File In Section: Product Recalls
Bulletin No.: 09047A
Date: May 2010

PRODUCT SAFETY RECALL

SUBJECT: Engine Compartment Fire

MODELS: 1997-2003 Buick Regal
1998-1999 Chevrolet Lumina
1998-2003 Chevrolet Monte Carlo
2000-2003 Chevrolet Impala
1998-1999 Oldsmobile Intrigue
1997-2003 Pontiac Grand Prix
Equipped with 3.8L V6 Naturally Aspirated Engine (RPO L36 – VIN K)

2257354

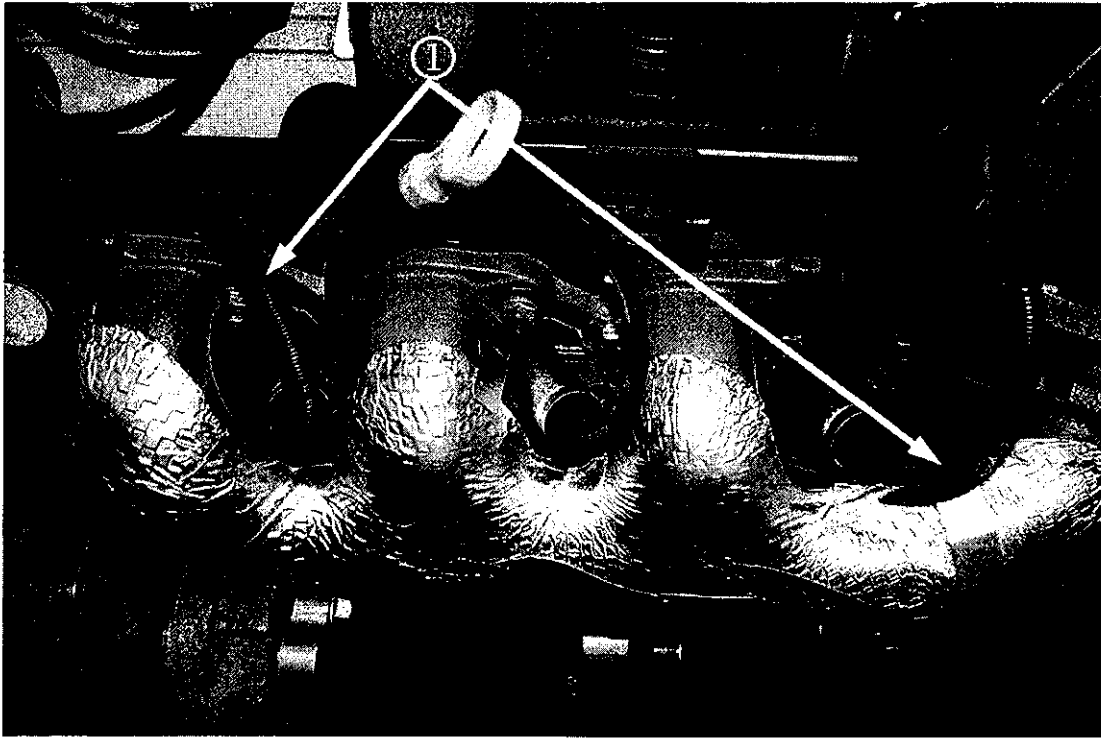
2. Remove the 1-3-5 spark plug plastic retaining channel (cover) clip/bracket (2) from the engine and discard it.

2473373

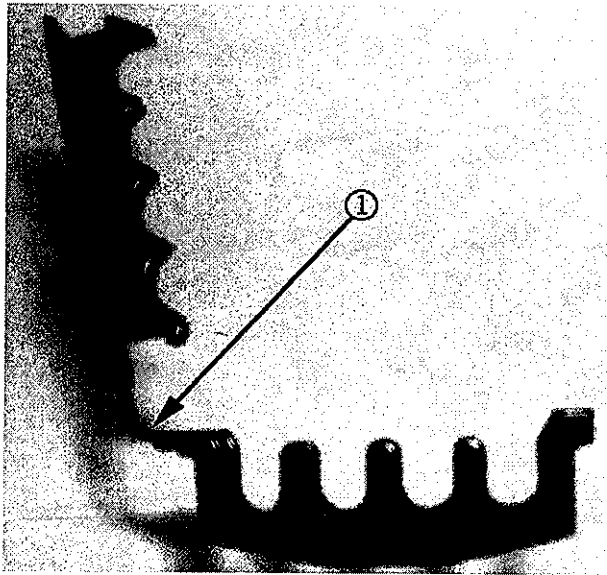
3. If present, remove any plastic (polypropylene) conduit (1) from spark plug wires at the front of the engine (should only be found on spark plug wires 1 and 5).

2092633

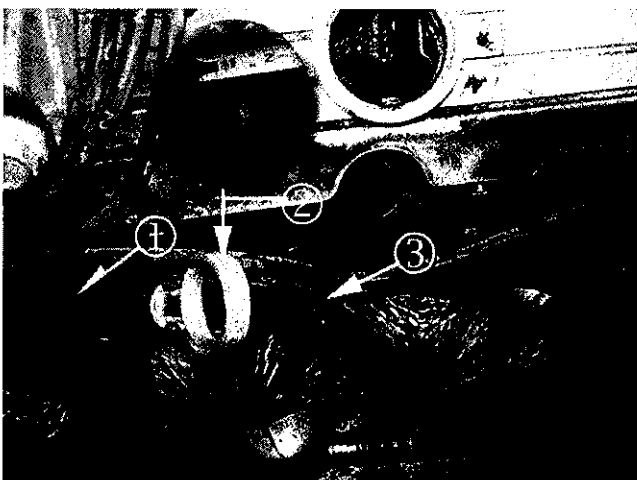
4. Install a 7 mm four-wire retainer, P/N 88891792 (1) (qty 5/pack) to spark plug wire number 4, then to spark plug wires 1, 3 and 5. Save the other 7 mm or 8 mm spark plug four-wire retainers for future repairs. Make sure that spark plug wires 2, 4 and 6 are secured to the original retainers and under the left engine mount strut bracket (2).

Important: If a 7mm four-wire retainer is not available, use a 8 mm four-wire retainer (1), P/N 14066248 (qty 10/pack), or equivalent 7mm aftermarket spark plug wire retainer.

2257363

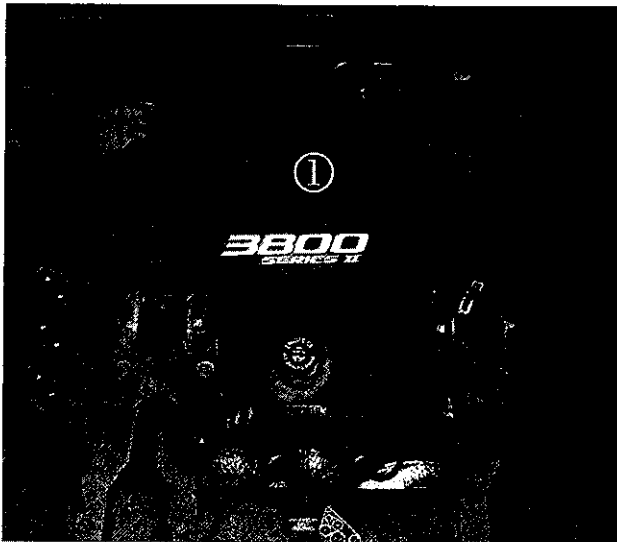
5. Install a 7 mm two-wire retainer, P/N 12132229 (Qty 10/pack) to spark plug wires 3 and 5 only (3). Save the other 7mm spark plug two-wire retainers for future repairs. Make sure the spark plug retainer (3) is approximately 50 mm (2 in) from the oil level indicator (2).

Important: Ensure that spark plug wires 3 and 5 are routed behind the oil level indicator and lift bracket. Ensure that the two-wire retainer (3), P/N 12132229, is positioned above the 3 spark plug wire boot. Do NOT position the retainer (3) above an exhaust runner.
